Amendments to the Drawings

Remarks

GEMFIRE c/o Haynes Beffel & Wolfeld LLP P.O. Box 366 Half Moon Bay, CA 94019 (650) 712-0340 phone Inventors: van der Vliet
Title: Optical Splitter with Tapered Multimode
Interference Waveguide
Application No. 10/521,086
Attorney Docket No. GEML 4793-3

FIG. 9

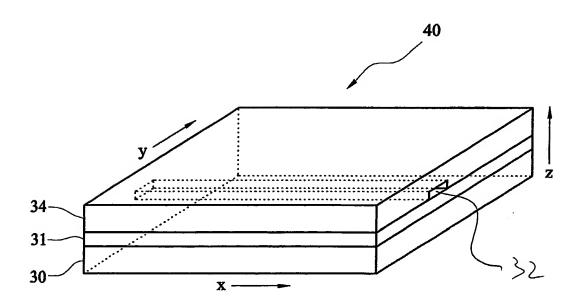
The attached sheet of drawings includes changes to Fig. 9. This sheet, which includes Figs. 8 and 9, replaces the original sheet including Figs. 8 and 9. In Figure 9, previously omitted element 32 has been added.

The Examiner has objected to the drawings as failing to comply with 37 C.F.R. §1.84(p)(5) because they do not include the following reference sign mentioned in the description: "silica cores 32."

However, the PLC 18 in Fig. 5 may be different from the PLC 40 in Fig. 9. This can be seen by the indefinite article "a" used when introducing the PLC chip 40, in the PCT-published specification at page 7, line 29 ("a PLC chip 40"). The two PLC chips are therefore properly given a different reference numeral. 37 CFR 1.84(p)(4) does not apply because Figs. 5 and 9 are not different "views" of a single drawing.

This has been corrected by adding the reference sign in Fig. 9. The designation was included in the informal drawings filed with the original PCT application but was accidentally omitted from the formal version of the drawings.
